# Ventura County Cultural Heritage Board

**OXNARD CULTURAL HERITAGE BOARD  
STAFF REPORT AND RECOMMENDATIONS  
AGENDA OF MARCH 28, 2011  
ITEM NO. 4a**

Landmark No. 161, 210 South F Street, Oxnard; Exterior and Interior Improvements and Removal of Four Trees, Project No. 11-332, Request for a Certificate of Appropriateness.

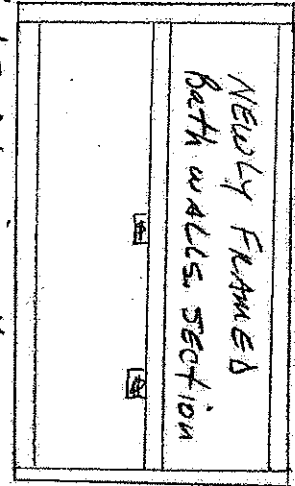
2 Aluminum window to be changed to wood or wood clad

1. Both windows are currently aluminum and will be replaced with wood windows or wood clad.
2. Bathroom lights to be CFL.
3. Bathroom light switch to be occup. sensor switch.

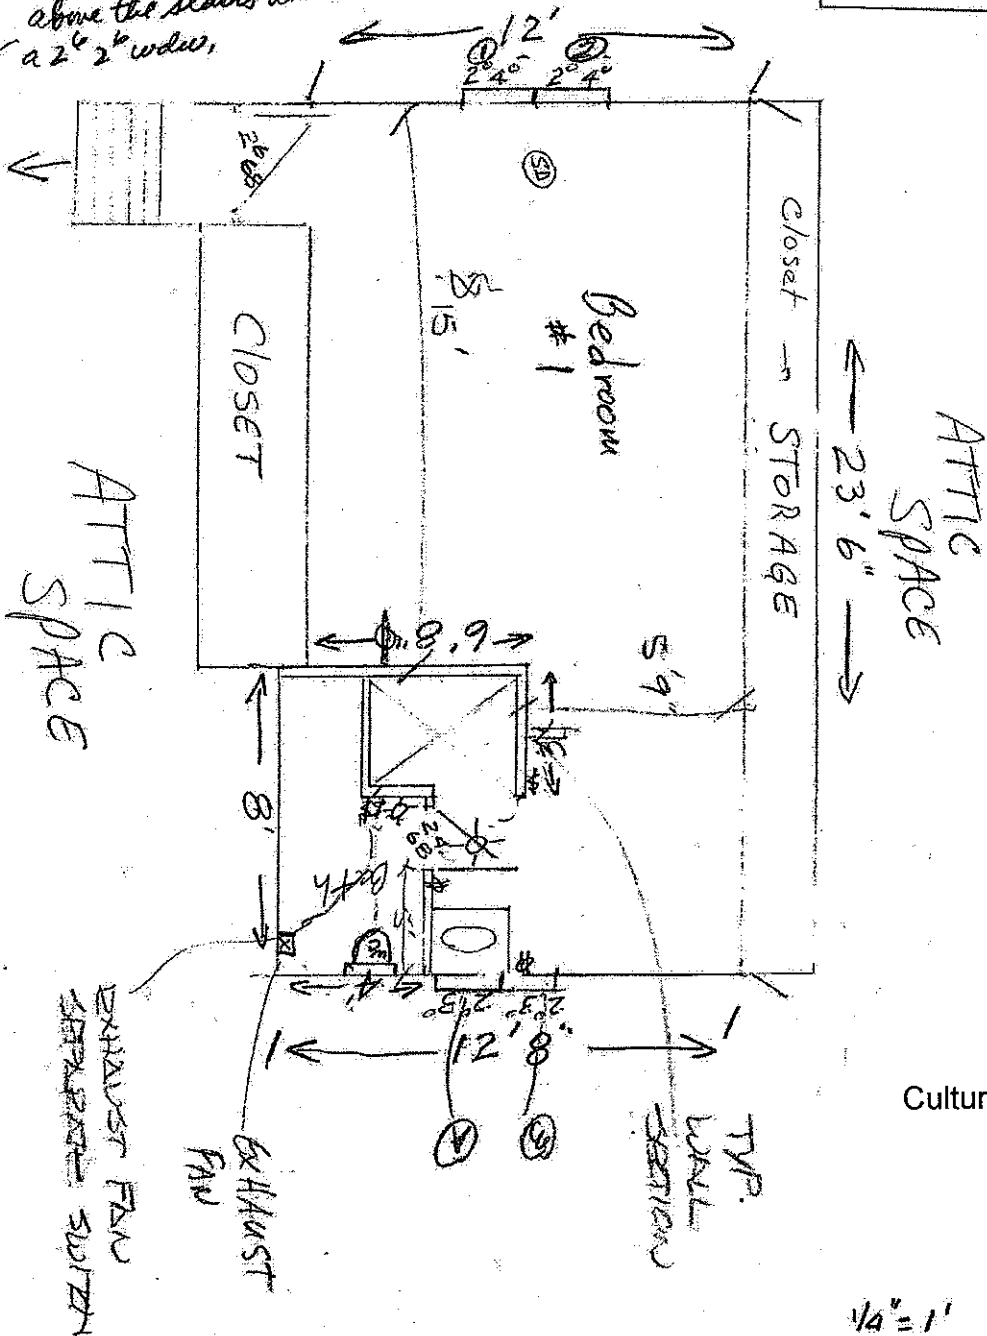
1. 2x4 framing, 16 oc.
2. wall framed to floor & ceiling w/ 16d nails.
3. Walls to be covered with 1/2" sheetrock.

Note: There is a dormer above the stairs with a 2' x 2' window.

Cultural Heritage Board  
Exhibit 5

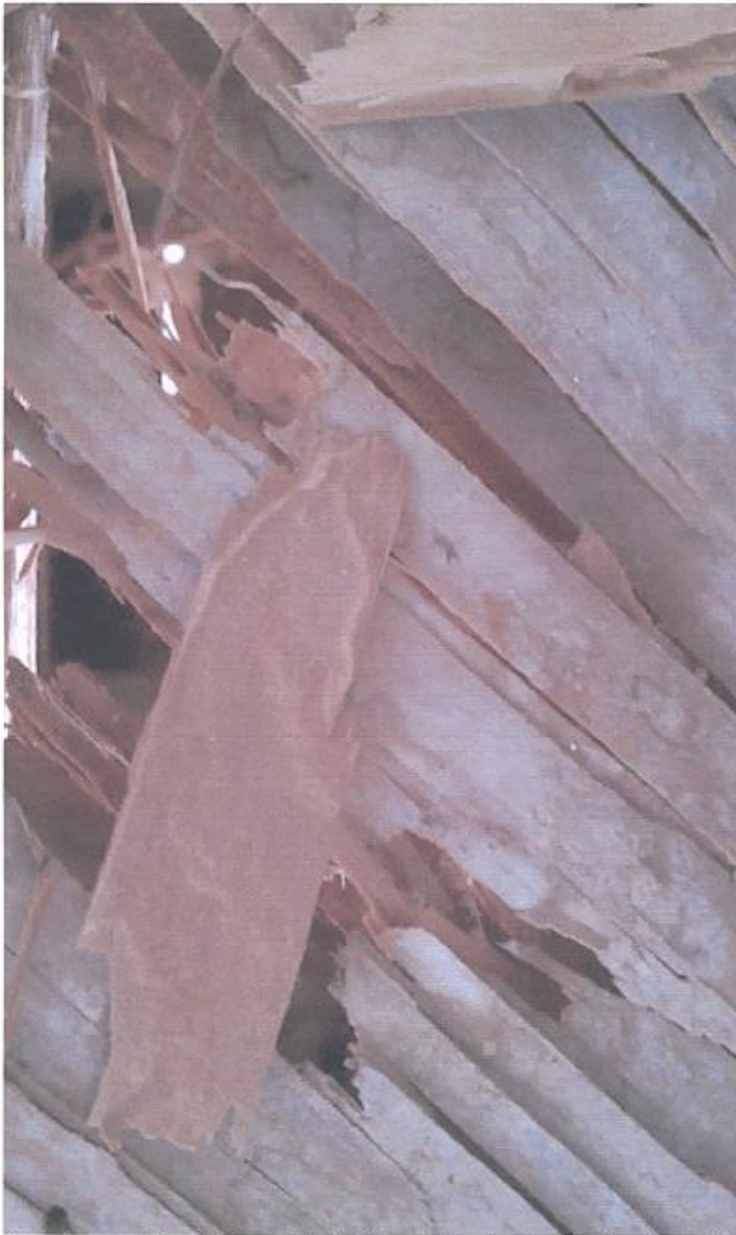
Upstairs, we removed the paneling, the drywall behind it, the beaver board on the ceiling and the carpet. We would like to replace these aluminum windows with wood or wood clad and turn the closet you see here into part of a second bathroom for the house.
